ORIGINATION FORM

Proposed Revisions to a Standard Plans Index (Please provide all information — Incomplete forms will be returned)

Index Number: 700-040
Sheet Number (s): 2
Index Title: Cantilever Sign Structure

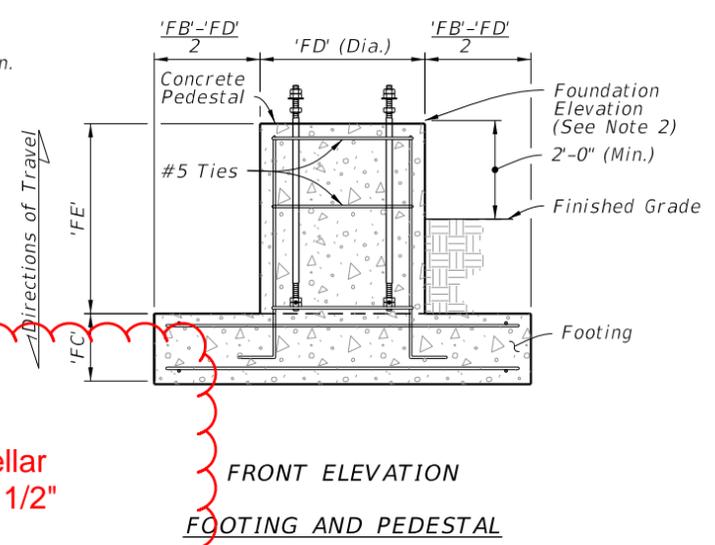
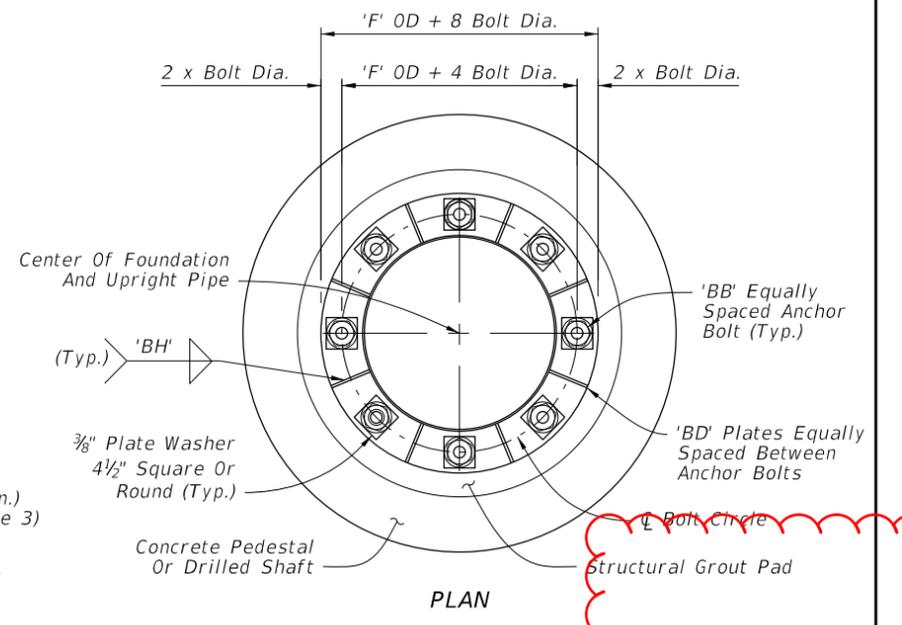
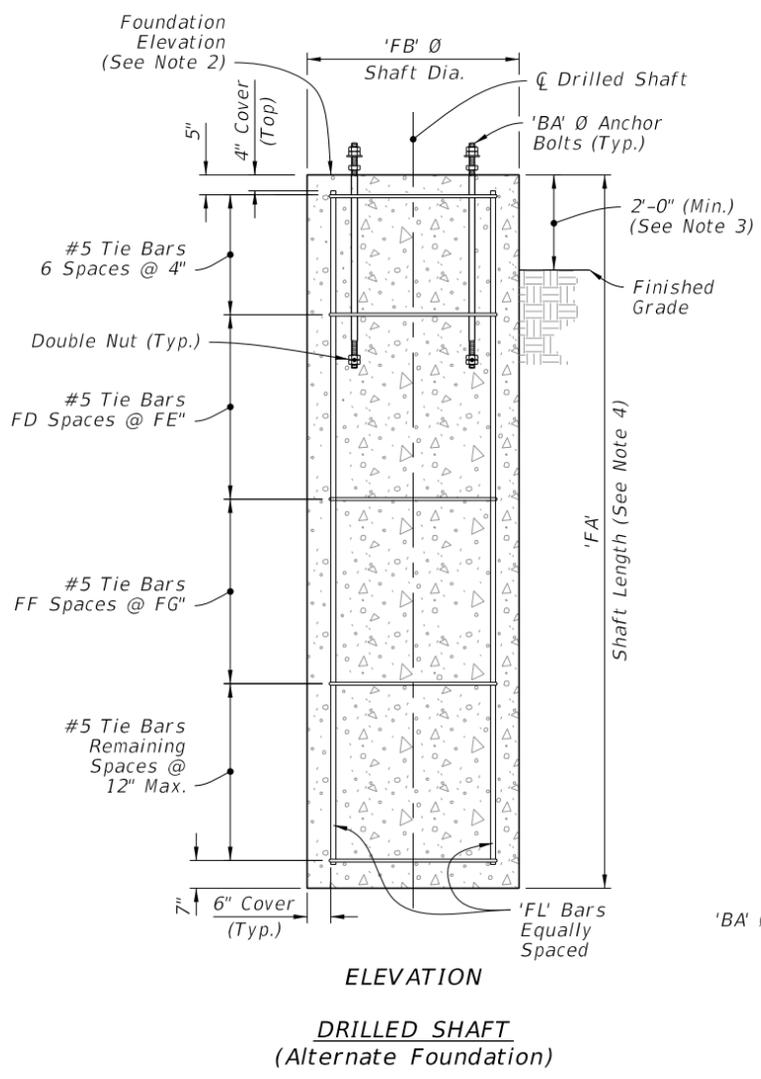
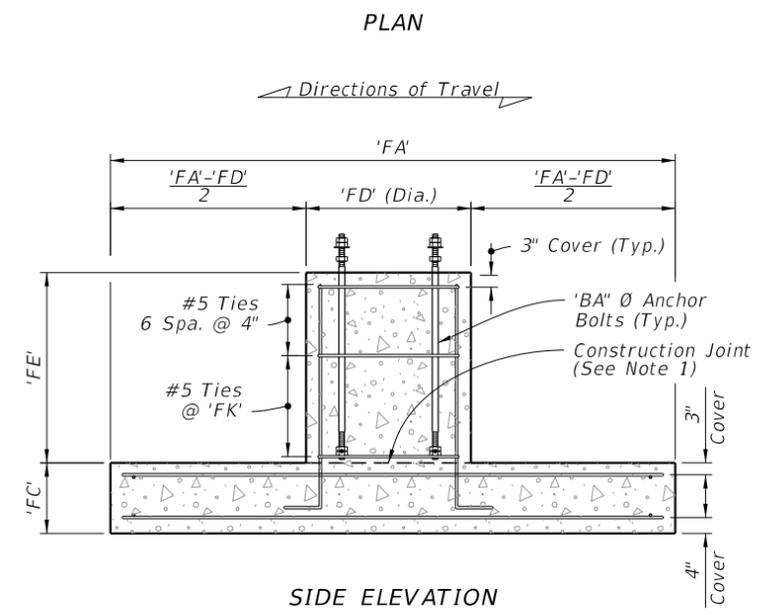
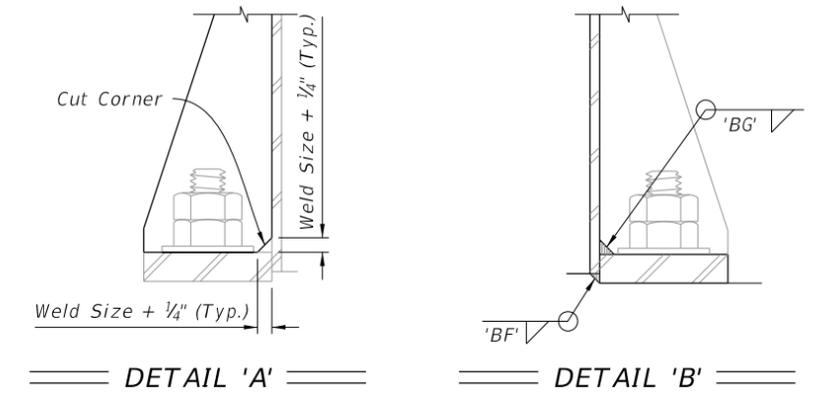
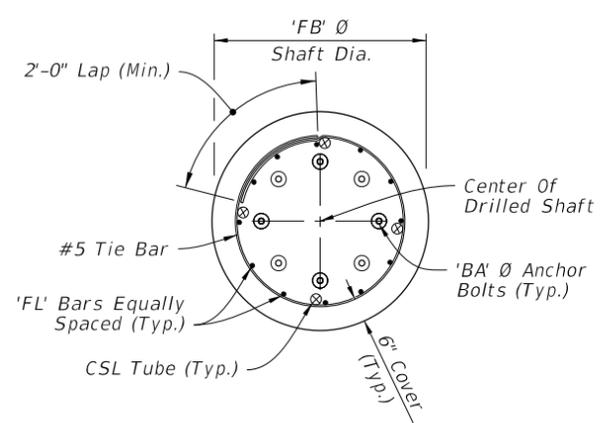
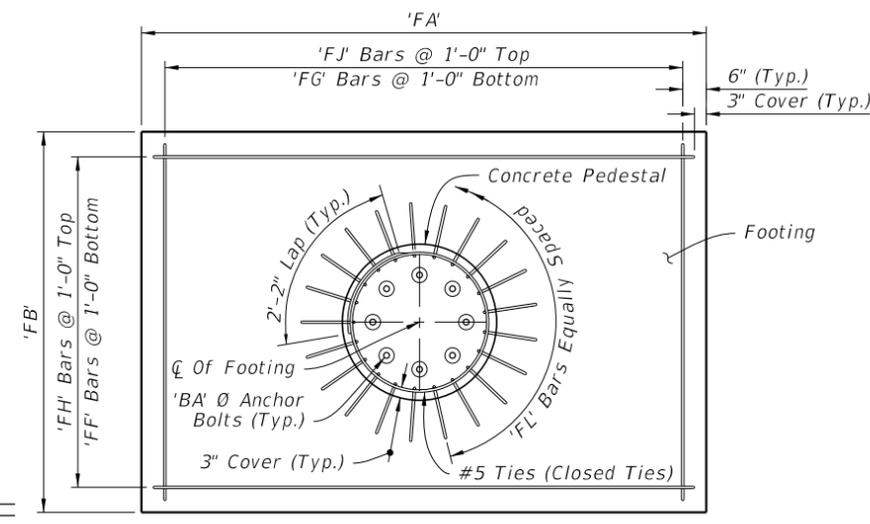
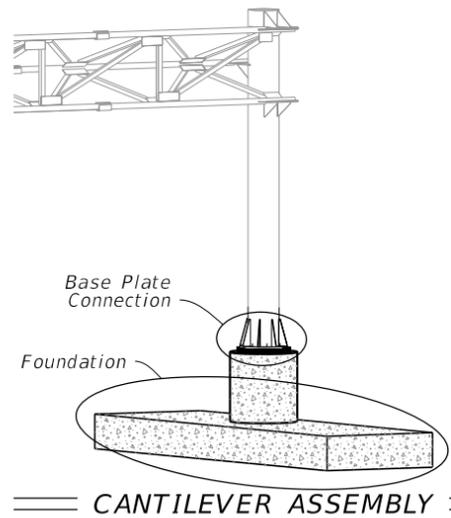
Added Note 7 and reference to the note.

Due to issue with tearing at the top of the stiffeners, adding a requirement for extra testing when poles are greater than 0.5" thick.

7. Provide ultrasonic Testing for Lamellar Tearing when wall thickness exceeds 1/2"
